Interactive comment on “Measurements of Hydrodynamics, Sediment, Morphology and Benthos on Ameland Ebb-Tidal Delta and Lower Shoreface” by Bram C. van Prooijen et al.

Bram C. van Prooijen et al.

Received and published: 7 September 2020

Fig. 1. interactive map with locations of the measurements.

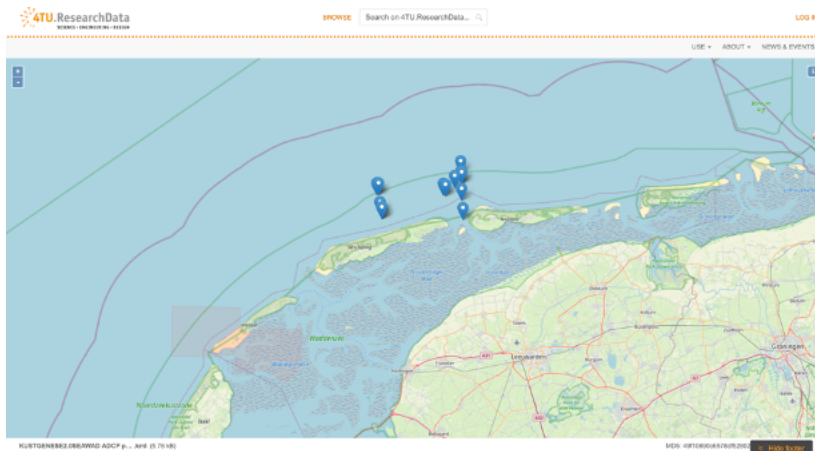
It would be helpful to add a table of dates and coverages for the platforms/instruments, unless this is somewhere in the repository/supplemental that I didn't see.

[We included a table with the frames for the different campaigns. See table 2 in the text. Furthermore, the site where the data is stored provides viewing options now as well. The position of the frames is directly visible on an interactive map, see for example Figure 1 or: \[https://data.4tu.nl/articles/dataset/KUSTGENESE2_0_SEAWAD_Frame-Mounted_Velocity_Profiler/12705962\]\(https://data.4tu.nl/articles/dataset/KUSTGENESE2_0_SEAWAD_Frame-Mounted_Velocity_Profiler/12705962\)](#)

Fig. 2. calibration of one of the compasses

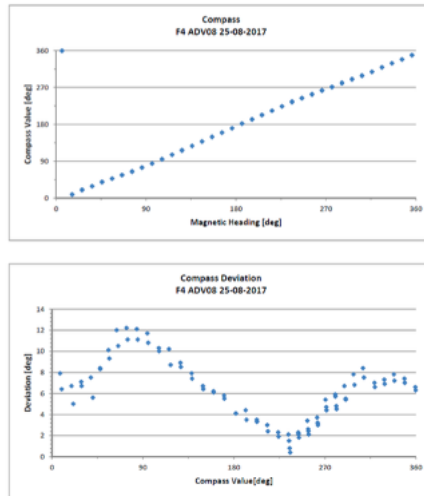
Within the text, it would be good to document the pre-deployment calibration steps for the various instruments. As it stands the calibration for only one instrument is described (LISST), and it is embedded in the post-processing section. I would at least add documentation on calibration of the optical sensors, compass calibrations for the velocity meters, and pressure-zeroing for the pressure sensors. It may seem trivial but it is important for inter-operability to know how instruments were prepared.

[We agree that this aspect was not sufficiently described. Compass calibration for the instruments on the frames was carried out prior to the campaign. An example result](#)

is shown below. We briefly explain the procedure in the text: *“The procedure for determining the offset of the compass was to rotate the mounting frame annotating every ten degrees the device heading angle (compass heading) and the true angle measured with high accuracy GPS (magnetic heading) not affected by the frame. This was repeated in reverse direction. An averaged compass deviation (from the two cycles) at a 10-degree interval was taken for the compass calibration.”*
